BUCKLEY ESTATES SUBDIVISION

Engineering Comments: FINAL PLAT COMMENTS (should be addressed prior to submitting the FINAL PLAT for review and/or signature by the City Engineer):

APPLICATION NUMBER 5 DATE December 21, 2017

DETAIL SITE PLAN

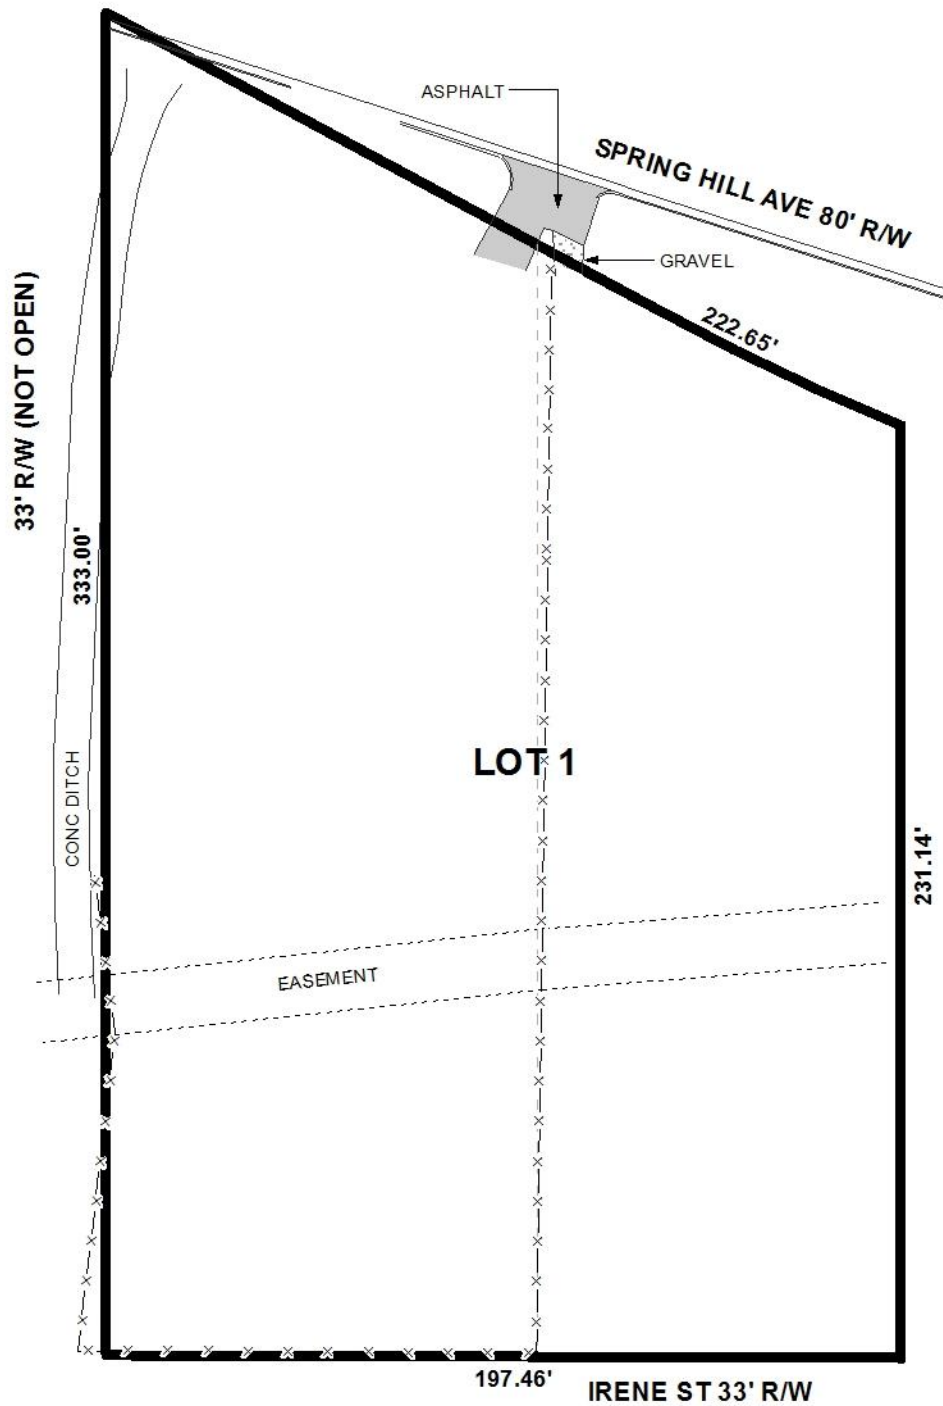
- B. Add legible street names to the vicinity map.
- C. Show and label LOT 45 that is referred to in the written legal description.
- D. Label the lines drawn parallel to the existing water line. Provide an easement as required by MAWSS.

- E. Provide and label the monument set or found at each subdivision corner.
- F. Add a signature block for the Owner, Notary Public, Planning Commission, Traffic Engineer, and City Engineer.

- I. The proposed subdivision appears to receive drainage that will require a drainage easement; the width and alignment of the easement shall be coordinated with, and approved by, the City Engineer. Additional width may be required to allow vehicular and equipment access.

The proposed lot has frontage on Spring Hill Avenue, a major street requiring a 100' right-of-way per the recently adopted Major Street Plan. The preliminary plat illustrates an 80' right-of-way and should, therefore, if approved, be revised to provide dedication 50' from the centerline of Spring Hill Avenue.

The proposed lot also has frontage on Irene Street, a minor street with a substandard 33' of right-of-way. The plat illustrates as much, but previous approval of a nearby Subdivision at the October 16, 2003 meeting of the Planning Commission required dedication along Irene Street to provide 25' from its centerline. As such, revision of the preliminary plat should be required, if approved, to also provide dedication 25' from the centerline of Irene Street.

It should be noted that an unopened 33' wide right-of-way is illustrated along the West property line. While sufficient dedication would normally be required, the applicant has provided a statement that the right-of-way has never been opened or used as a roadway; rather, that the City uses the right-of-way for drainage, which is perhaps evidenced by an existing concrete drainage ditch. The applicant also mentions that previous subdivision approval in 1992 of the lot adjacent to the right-of-way did not require dedication and, as such, is requesting a similar waiver of dedication for the proposed lot. Staff confirms that previous dedication was not required by the Planning Commission 1992, thus a waiver of Section V.B.14. may be appropriate.

The applicant is also requesting that the minimum setback requirement along the existing 33' of right-of-way be 8' instead of the greater 12' minimum setback required at this particular site for a side street, side yard. Such setback requirements are codified in Sections V.D.5. and V.D.9. of the Subdivision Regulations, and 64-4.D.3. of the Zoning Ordinance.

Review of the proposed site improvements shows that the reduced setback would accommodate the proposed garage with a second floor dwelling; however, the reduced setback is not justified when, as a result of the proposed Subdivision, the size of the lot would provide sufficient options to comply with the applicable setback requirements. If approved, a waiver of Section V.D.5. and V.D.9. of the Subdivision Regulations would be required. It should be noted, however, that while such a waiver would make an exception to the Subdivision Regulations, a Variance approved by the Board of Zoning Adjustment will be required to address Section 64-4.D.3. of the Zoning Ordinance.

The minimum building setback lines required by Sections V.D.5. and V.D.9. of the Subdivision Regulations are not illustrated on the preliminary plat; therefore, revision of the plat to illustrate

the appropriate minimum building setback lines along all frontages should be required, if approved, including a 25' setback along Irene Street, adjusted for any required dedication.

- 1) revision of the plat to illustrate dedication sufficient to provide 50' from the centerline of Spring Hill Avenue;
- 2) revision of the plat to illustrate dedication sufficient to provide 25' from the centerline of Irene Street;

- 3) revision of the plat to illustrate the 25' minimum building setback lines along Spring Hill Avenue and Irene Street, adjusted for dedication;
- 4) revision of the plat to illustrate the 12' minimum building setback line along the 33' unopened right-of-way of Dogwood Lane, if approved by the Board of Zoning Adjustment, otherwise a 25' setback is required;

- 5) retention of the lot size in square feet and acres on the Final Plat, or provision of a table providing the same information, adjusted for dedication;

- 6) placement of a note on the Final Plat stating the lot is limited to one (1) curb cut per open street frontage, with any changes in their sizes, locations or designs to be approved by Traffic Engineering and conform to AASHTO standards;
